INSTRUCTION TO SERVICE

ITS: 5118	
SECTION:	549 HVAC
WRITTEN BY:	Kevin Robinson
SUBJECT:	Remove and replace copper lines at the booster pump

**Complete this ITS for SR1492, SR1493, SR1508, SR1509
and SR1516 ONLY.**

Figure 1 – Clamp Plates (Aux heater and engine removed for clarity)

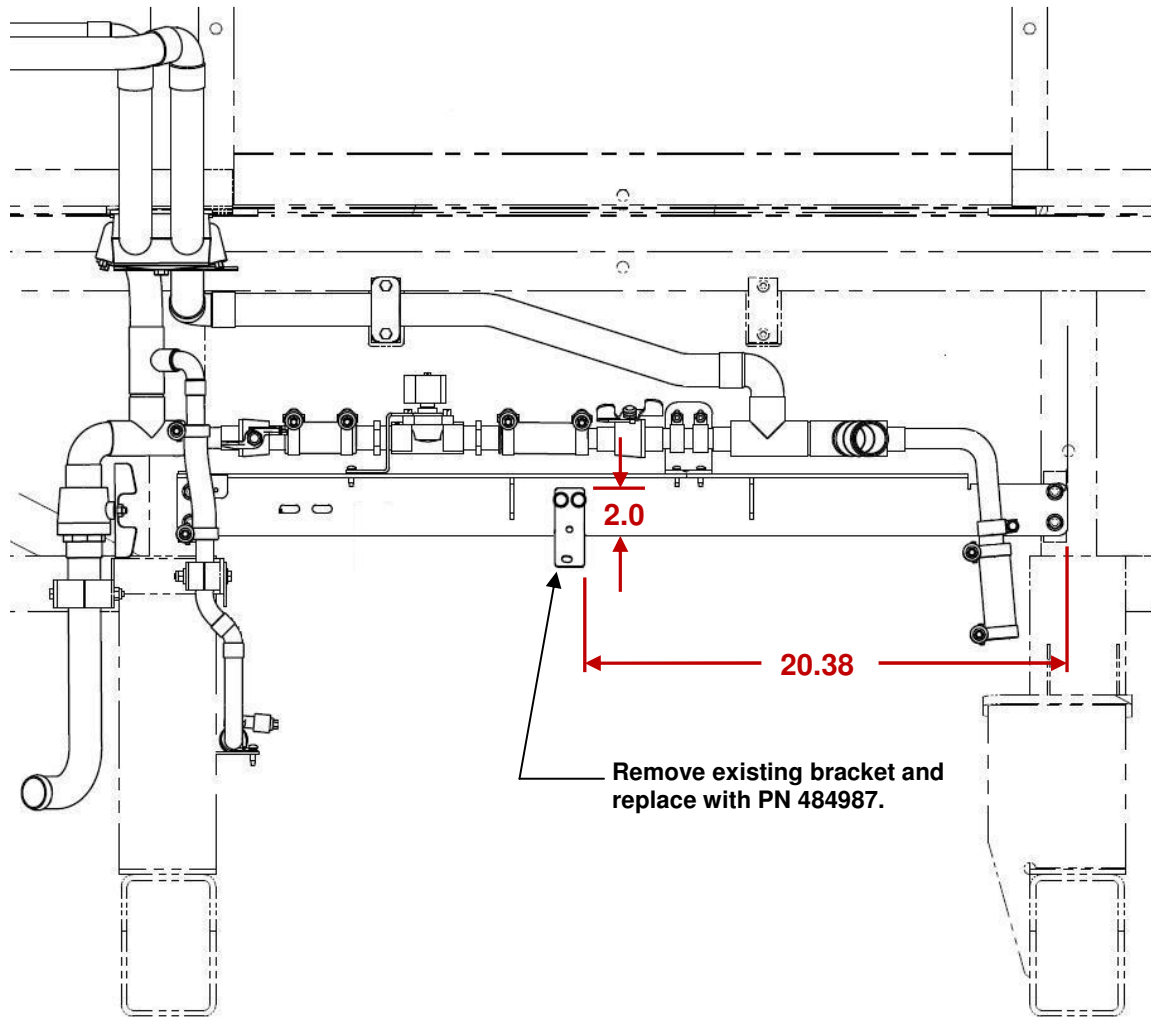
10. Place the supplied clamp support bracket (NF PN 484987) in the location shown in Figure 1 and secure it in place with two 1/4 inch self tapping screws.(NF PN 34S04012) and two flat washers (NF PN 10W04000). Notch behind the bracket as required for clearance. Apply primer to bare metal revealed by removal of the clamp plate. Refer to Appendix A for primer application instructions.

Figure 2: Clamp Plate Swap Out

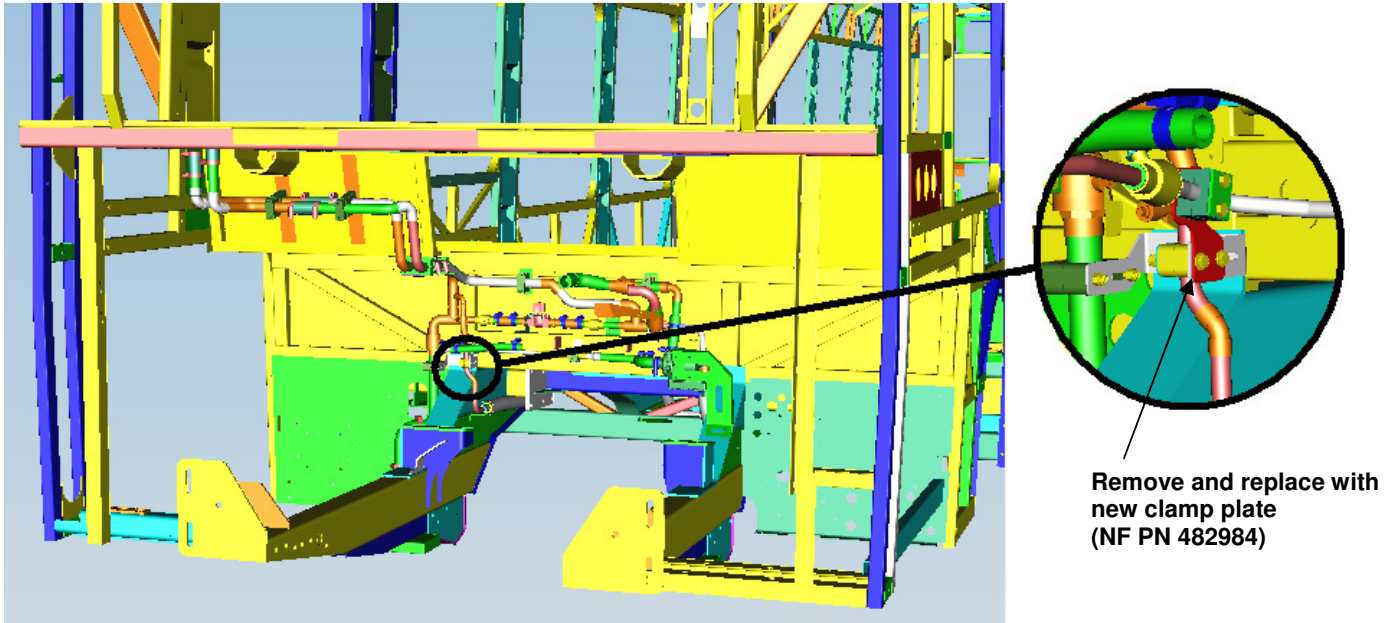
11. Remove the clamp plate from the tube clamp that supports the vertical tube from the under floor heater lines on the street side of the bus and replace it with the new supplied clamp plate (NF PN 482984). Secure the new plate with the hardware removed from the old one but replace the two nuts with new ones (NF PN 40N04000).

Figure 3: Placement of New Booster Pump Bracket

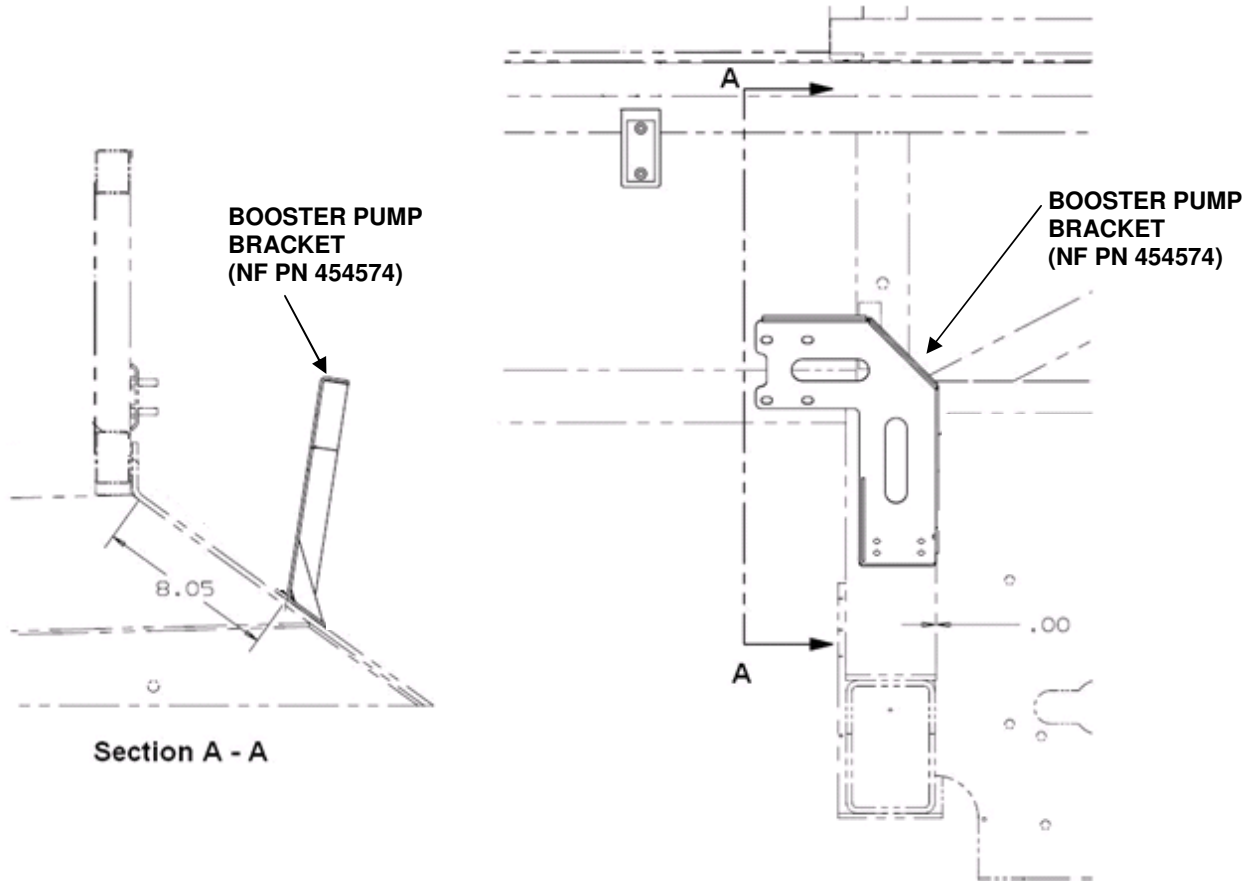
12. Replace the booster pump bracket.
 - a. Remove the existing booster pump bracket, by grinding, from the bus and discard.
 - b. Place the new booster pump bracket (NF PN 454574) in place where the previous one was removed from using dimensions shown in Figure 3 and mark the centers of the four mounting holes.

- c. Drill out the four holes using an F sized drill bit (0.257 dia) and then tap 5/16-18 UNC.
 - d. Apply primer to any exposed metal. Refer to Appendix A for primer application instructions. Secure the new booster pump bracket (NF PN 454574) with supplied 5/16-18 bolts (NF PN 20B05012), 5/16 lock washer (NF PN 51W05000) and 5/16 flat washer (NF PN 50W05000). Torque to 27 ft lbs.
